O'FALLON AND O'FALLON FIRST ADDITION **SUBDIVISION**

APPLICATION NUMBER 27 DATE October 3, 2013

APPLICANT O'Fallon and O'Fallon First Addition Subdivision

DETAIL SITE PLAN

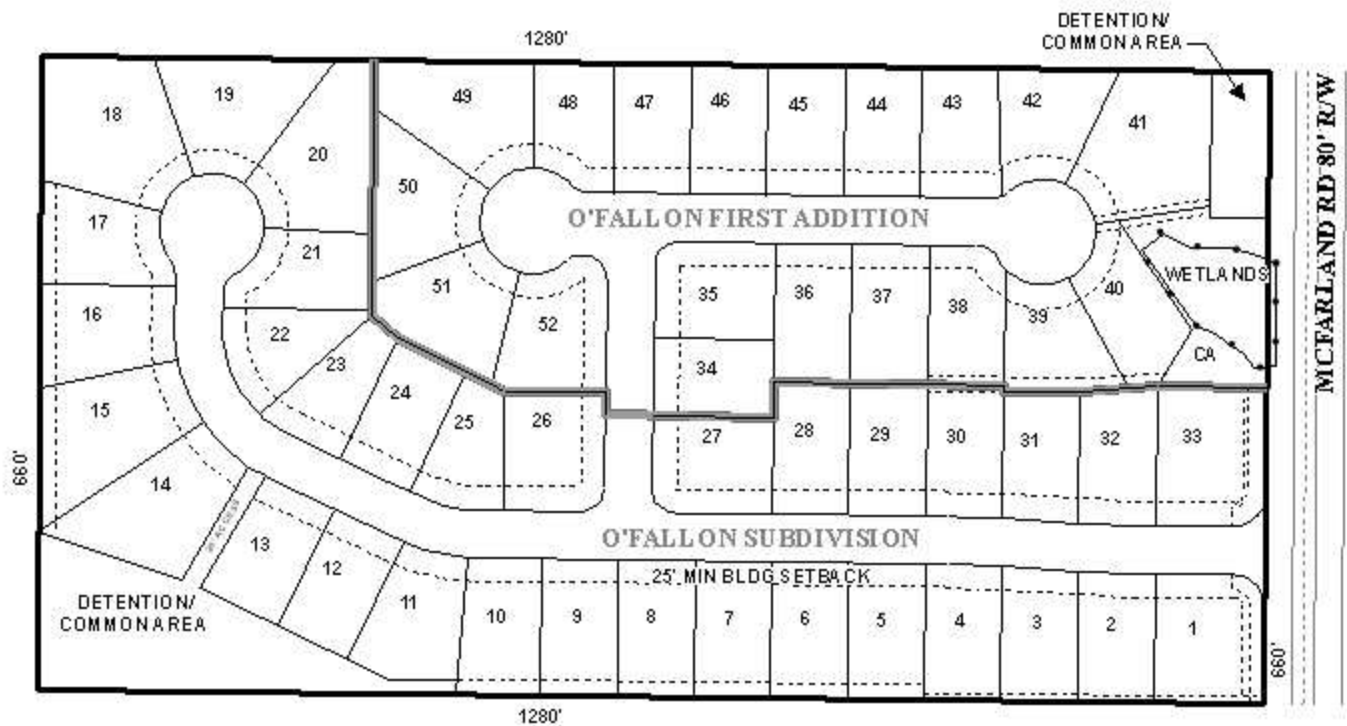
Although it does appear that all lots meet minimum size requirements any lots less than 7,200 square feet must be resized to comply with the Subdivision Regulations. Lot sizes for are not labeled on the preliminary plat. Labeling of the lot area size, in square feet, or provision of a table on the Final Plat with the same information will be required if approved.

The site fronts McFarland Road which is shown as a major street on the Major Street Plan component of the Comprehensive Plan. The preliminary plat submitted indicates that McFarland Road has a current 80' right-of-way; however, a minimum of 120' right of way is required by the Major Street Plan. Therefore, dedication of sufficient right of way along McFarland Road to provide 60' from centerline will be required.

Access management is a concern thus; a note should be placed on the plat stating that all lots and common areas fronting McFarland Road are denied access to McFarland Road. A note on the

final plat should be modified to state that each lot and detention/ common area access is limited to one curb-cut, with the size, design and location to be approved by Mobile County Engineering.

Development of the site will require the construction of new streets. All roads must be built to County standards and accepted by the County, prior to the recording of the Final Plat. Furthermore, the location of the proposed 20-foot wall as depicted on the plat will be subject to the approval of County Engineering.

The site has closed-end streets that exceed 600 feet. Thus, a waiver of Section V.B.6 of the Subdivision Regulations shall be required. According to the design standards and right-of-way widths located in the Subdivision Regulations a closed-end street must have a turnaround right-of-way diameter of 120 feet, however, the plat only reflects a diameter of 110 feet. The cul-de-sac diameter should be revised to comply with Section V.B.14. of the Subdivision Regulations, and revised lot sizes shall be required for any lots that abut each cul-de-sac.

The site has property lines at an intersection corner. Section V.D.6. of the Subdivision Regulations requires that *“property lines at street intersection corners shall be arcs having radii of at least 10 feet or shall be chords of such arcs.”* The curb radii is depicted on the preliminary plat, and if approved should be depicted on the final plat as well.

Three common areas are depicted on the preliminary plat. There is also a 20-foot wall and landscaping easement illustrated at the entrance to the subdivision. A note should be placed on the final plat, if approved, stating that maintenance of the common areas and the 20-foot wall and landscaping easement is the responsibility of the subdivision’s property owners.

The 25-foot minimum building setback is shown on the plat, and should be placed on the Final Plat, if approved. Revisions along McFarland Road due to dedication should be made and the illustration of the new 25-foot minimum building setback line should be depicted.

There are several drainage easements located on the site that lead to the common area and retention/ detention ponds. A note should be placed on the final plat stating that no structures shall be constructed or placed within any easements.

It should be noted that the site plan depicts limits of wetlands on the site which may indicate that the area is environmentally sensitive; therefore, the approval of all applicable federal, state and local agencies will be required for wetland issues.

There appear to be errors in the notes and site data table in regards to the total number of lots and lots that are denied direct access to McFarland Road. Revisions to the notes should be made to reflect what the plat depicts. Also, McFarland Road is listed as McFarland Drive on the preliminary plat. Revisions should be made to the plat to illustrate the correct labeling.

1. revisions to the site plan to depict dedication of sufficient right of way along McFarland Road to provide 60' from centerline;
2. revisions to the site plan to depict a turnaround right-of-way diameter of 120 feet;
3. revised calculations of lot sizes where the property abuts each cul-de-sac;
4. revision of all lot size calculations to reflect any modifications required due to right-of-way dedication or cul-de-sac changes, and labeling of all lots with their size in square feet; and
5. revise plat to illustrate the correct labeling for McFarland Road.
